TP-LINK CORPORATION PTE.LTD.

Subject: Requesting Class II permissive change for FCC ID: 2BCGWAP9665

The purpose of this letter is to request a Class II Permissive change for FCC ID: 2BCGWAP9665, original granted on 01/17/2024.

Page 11: T5:S24001 replaced with SHD24002.

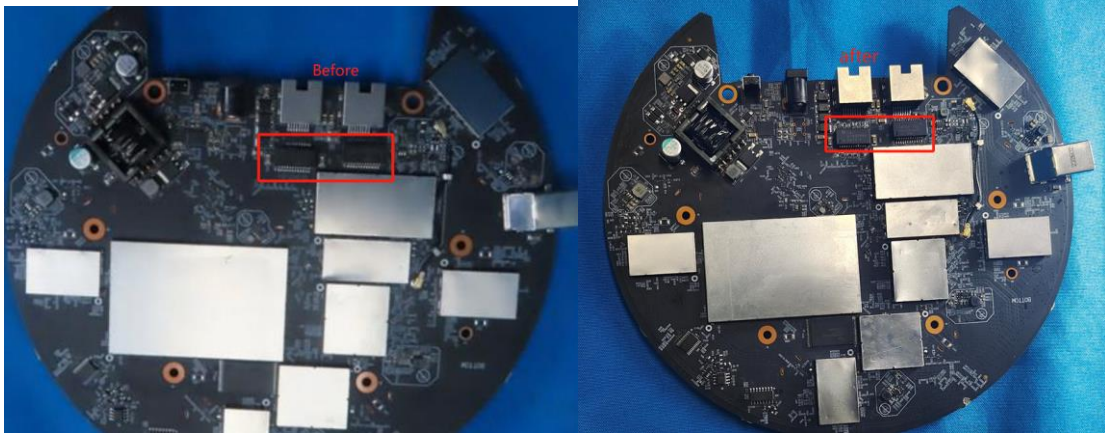
2. Change the signal transformer of the network port. (Update transformer model number.)
